Memorandum

Subject: Review Type: Z2025000111 (Zoning)
Applicant Name: 8445 SW 94th Street Mixed-Use Building

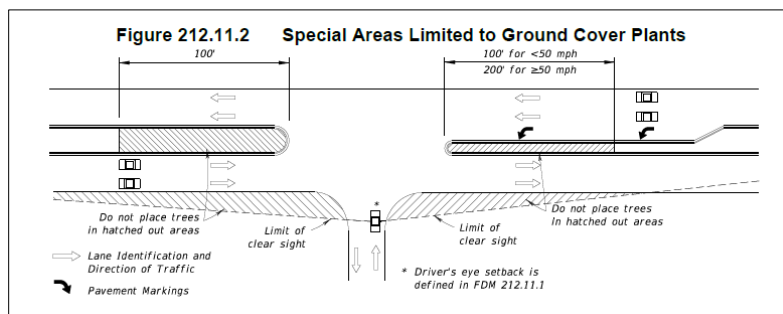
1. Exit driveways must comply with clear sight visibility requirements for both pedestrians and vehicular traffic. Provide clear sight visibility triangles on the site and landscape plans to demonstrate compliance with these requirements. Please ensure to clearly illustrate both (pedestrian and vehicular) sight triangles following the MDC Traffic Operations Manual and FDOT Standards. Note that according to the latest FDOT FDM manual

Section 212.11.6, trees may not be placed within the hatched-out areas of the sight triangles, as shown in the figure below.
